INDESIT company

Model type:
WITL105EU

Commercial code:
F034267

n1040345: Replacement of drum lock button TL EVOII.

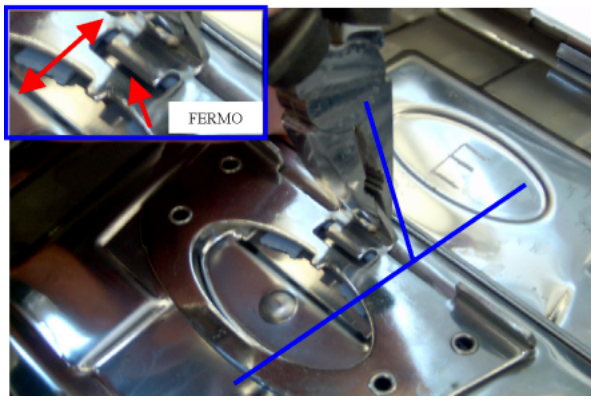
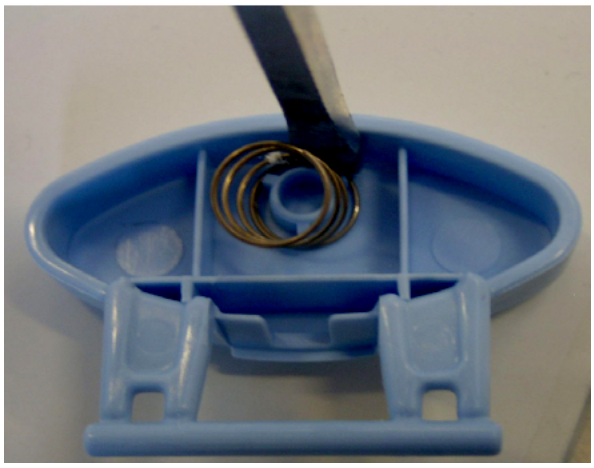
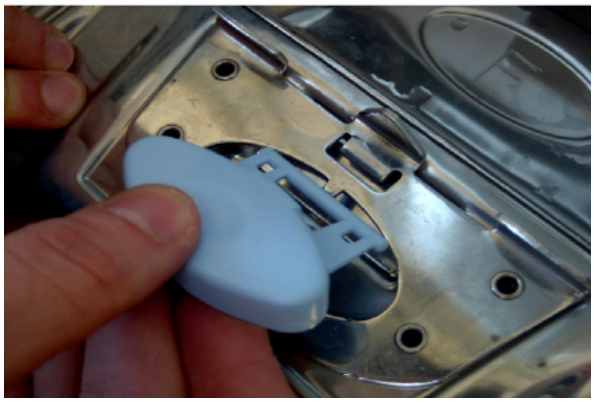
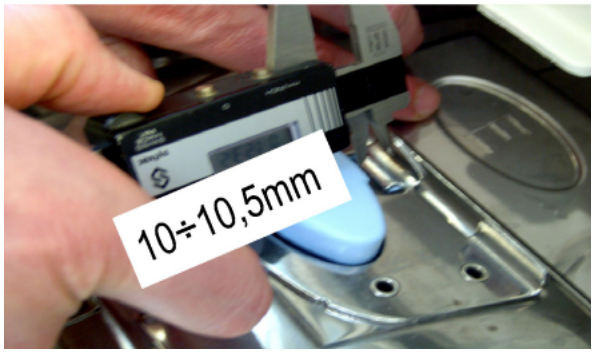
Tools and material needed: pliers, screwdriver, gauge, spring P/N Sat 114989, button P/N Sat 114990.

1) turn the central tip of the catch in the direction shown (FIG.1);

2) bring the tip to a vertical position and ensure that the broken button is disengaged from the catch restraint and can be removed (FIG.2);

3) remove the remaining part of the button with the aid of a screwdriver, taking care not to scratch the doors (FIG.3);

4) pre-assemble spring to button (FIG.4);

5) insert button between catch and door (FIG.5);

6) bring the button into position and arrange the spring in its location in the door (FIG.6);

7) turn the central tip of the catch in the direction shown to return it to its starting position (FIG.7);

8) check the distance between button and catch (FIG.8);

9) check correct operation of the button when opening and closing the doors (slight inclination errors of the catch can result in

faulty closing of the doors) (FIG.9).

n1040382: Drain pump with bayonet-style filter - top Loading Brembate

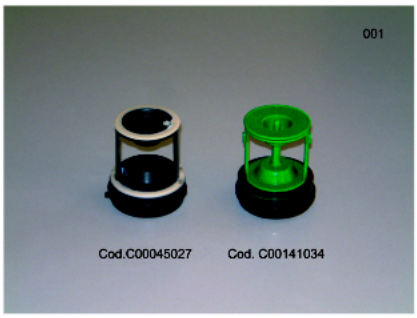
From serial no. 51021.0001 a new drain pump with bayonet-style filter has been installed on all top loading washing machines manufactured in Brembate.

New parts:
C00141862 - Drain pump
C00141034 - Pump filter kit

Premodification parts:
C00111409 - Drain pump
C00045027 - Pump filter kit

The new parts can be used instead of premodification ones.

N1040404FIG1

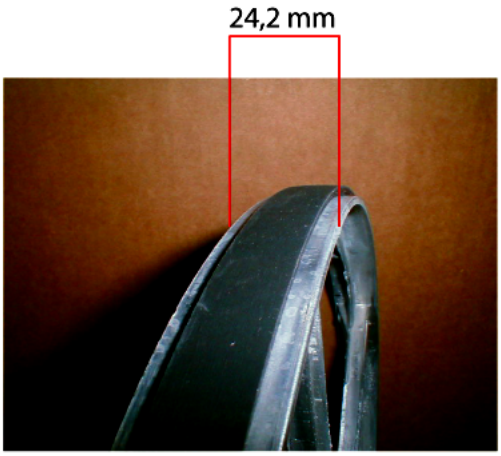
n1040404: New pulley installed on top loading washing machines up to 1000RPM (NO tub lock)

From serial no. 51202.0001 the pulley track has been widened from 21.2mm to 24.2mm (see picture N1040404FIG1).

new pulley
C00142832 - D280 24.2 mm track

Premodification pulley
C00083912 - D280 21.2 mm track

The new pulley can also be used on premodification versions of the models referred to in this release.
